Proposal for amendment to ECE/TRANS/WP.29/GRSG/2024/12

(Vulnerable Road Users in Front and Side Close Proximity)

Submitted by the expert from Japan

The text reproduced below was prepared by the experts from Japan to amend UN Regulation No. 166 for avoiding misunderstandings in the certification process. This proposal amends ECE/TRANS/WP.29/GRSG/2024/12. The modifications to the existing Regulation are marked in bold for new or strikethrough for deleted characters. The additional modifications to ECE/TRANS/WP.29/GRSG/2024/12 are marked in **Red**.

Figure 4
Monocular Fields
(Direct vision case)

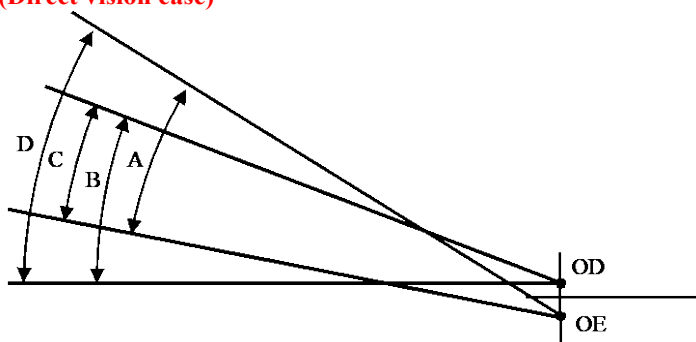
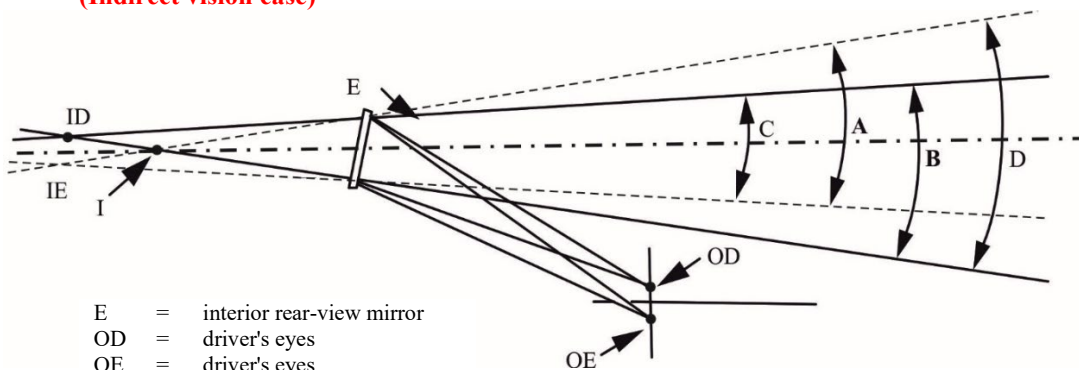
"12.2. "*Ambinocular vision*" means the total field of vision obtained by the superimposition of the monocular fields of the right eye and the left eye (see Figure 4 below).

1. Paragraphs 1.1.1. and 1.1.2.:
Footnote was missing for the references of vehicle categories.
2. Paragraph 1.1.3.:
This section describes the vehicle approval request by the manufacturer. Therefore, the part on approval (Part I) is not suitable.
3. Paragraphs 5.2. and 14.2.:
The description of approval number harmonized with the 1958 Agreement, Rev.3.
4. Paragraphs 6.1.3. and 6.2.:
The addition of impact safety requirements for mirrors copied from UN Regulation No.46 which reflects the latest amendment (GRSG-126-24r1) and exempt the devices approved by UN Regulation No. 26 or No. 61.
5. Paragraph 12.2.:
Figure was copied from Regulation No.46. It was for indirect vision only. "Ambinocular vision" is for both direct and indirect vision. To prevent misinterpretation, direct vision case figure was added.
6. Paragraphs 15.1., 15.2. and 15.2.1.:

Figure 5
Examples of Designated Area of Each Means (Right-Handed Drive Case)

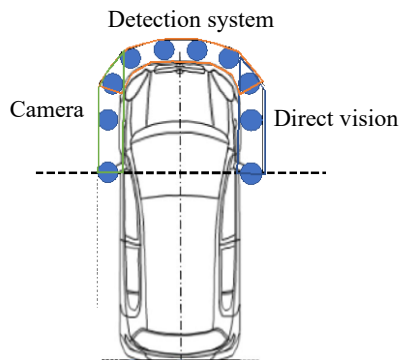
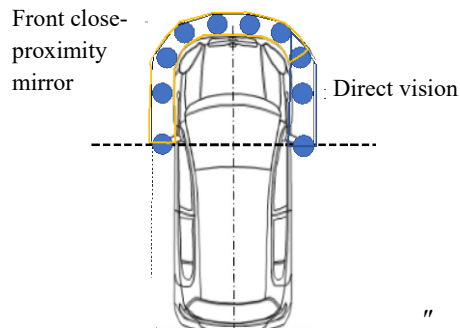
Overlaps of designated areas by different means (see examples in Figure 5) shall be permitted.

The manufacturer shall declare to the technical service which means is used for which designated area, so that the technical service can set up the testing equipment accordingly. This shall be recorded in the test report.

Reorganized between two paragraphs 15.1 and 15.2 for misunderstanding and for clear descriptions. The figures on pole location at the centre of the side mirror were updated to avoid misinterpretation.

Figure 6
Close-Proximity Front and Lateral Sides View Field of Vision

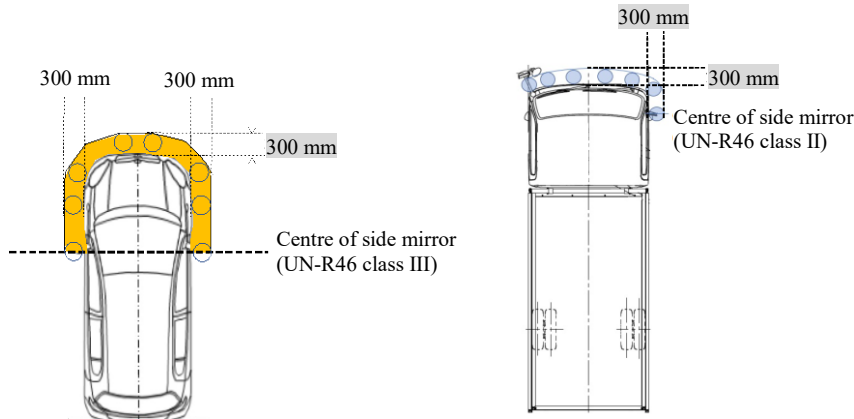
Paragraph 15.2., delete Figure 2 and amend to read:

The field of vision (see Figure 2 6 below) shall be bounded by the following planes:

- (a) A **longitudinal** ~~transverse~~ vertical plane passing through a point 300 mm from the contour of the sides of the vehicle;
- (b) A transverse **vertical** ~~horizontal~~ plane passing through a point 300 mm from the contour of the front of the vehicle;
- (c) Areas ahead of the centre of the side mirrors on the driver's seat side and the passenger seat side. In the case of the vehicle that equipped with CMS that comply UN Regulation No. 46, 04 Series of amendments, the

manufacturer shall consider the same vehicle equipped with side mirrors or to use the centre of Class III or II CMS camera lens instead of the centre of the side mirrors.

The contour shall be defined by the vehicle outside shape projection to the ground that can place the test object defined in Annex 9 of this Regulation (300mm diameter pole). Small outside shape irregularity is not included.

Figure 7
Example for the Measurement by Maximum Variation

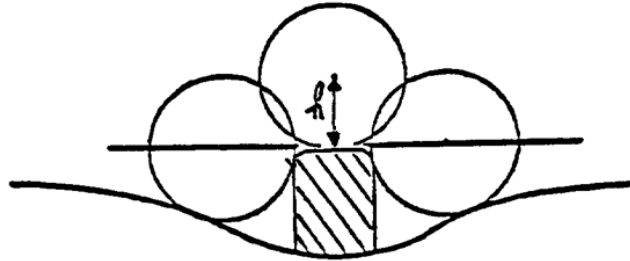
15.4.3.2.2. If the dimension of the projection of a component which is mounted on a surface other than convex cannot be determined by simple measurement, it shall be determined by the maximum variation of the distance of the centre of a 100 mm diameter sphere from the nominal line of the panel when the sphere is moved over and is in constant contact with that component.

Figure 7 shows an example of the use of this procedure.

Addition of impact safety requirements for FLVCS and Detection system same concept as mirror (6.1.3.). These requirements are modified for consistency with CMS requirements of Regulation No.46 Paragraph 6.2.

Figure 2
Test Object Locations

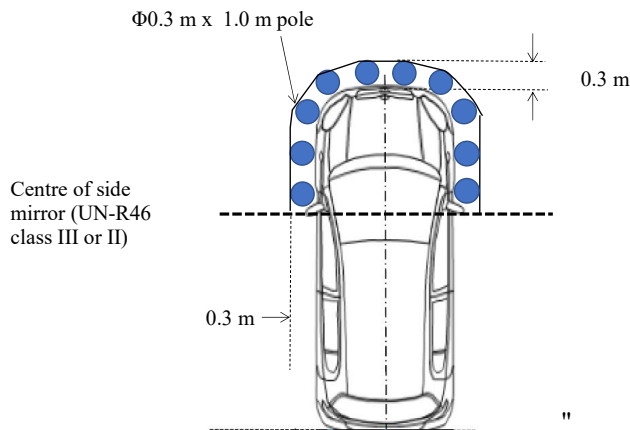
- "1.2. The test object shall be in contact with the vehicle's front and lateral side from the centre of passenger side mirror to driver's side mirror shall be seen in the close-proximity front and lateral view field of vision. In the case of the vehicle that equipped with CMS that comply UN Regulation No. 46, 04 Series of amendments, the manufacturer shall consider the same vehicle equipped with side mirrors or to use centres of Class **III or II** CMS camera lens instead of the centres of the side mirrors.

Add the description for the Class II mirror in the figure.

Necessity of Pendulum Impact Test

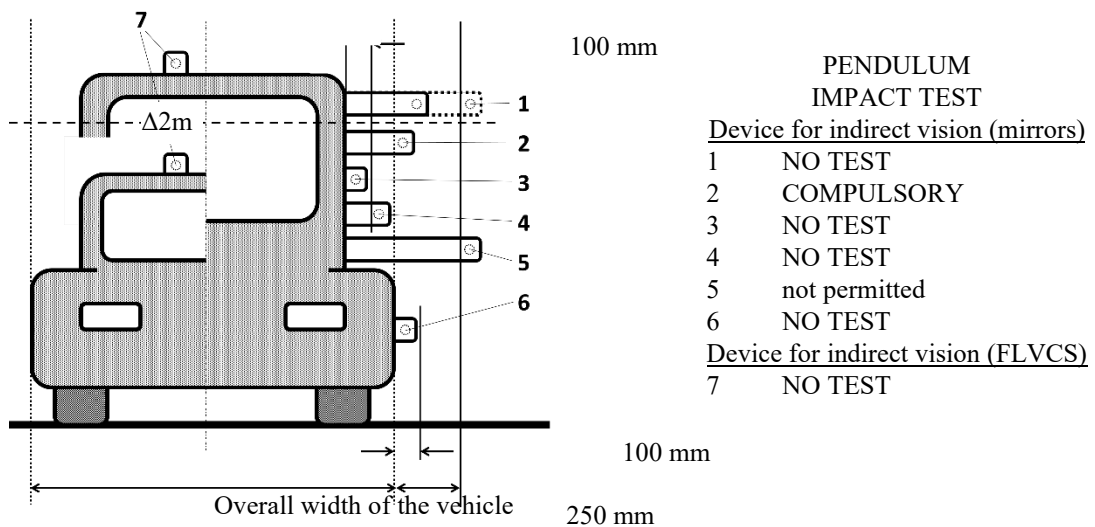
- (b) devices not protruding more than 100 mm measured at the attachment point beyond the circumscribing external original surface of the vehicle according to UN Regulation No. 26 (See Annex 13).

Reflects the latest amendment of UN Regulation No. 46 (GRSG-126-24r1).
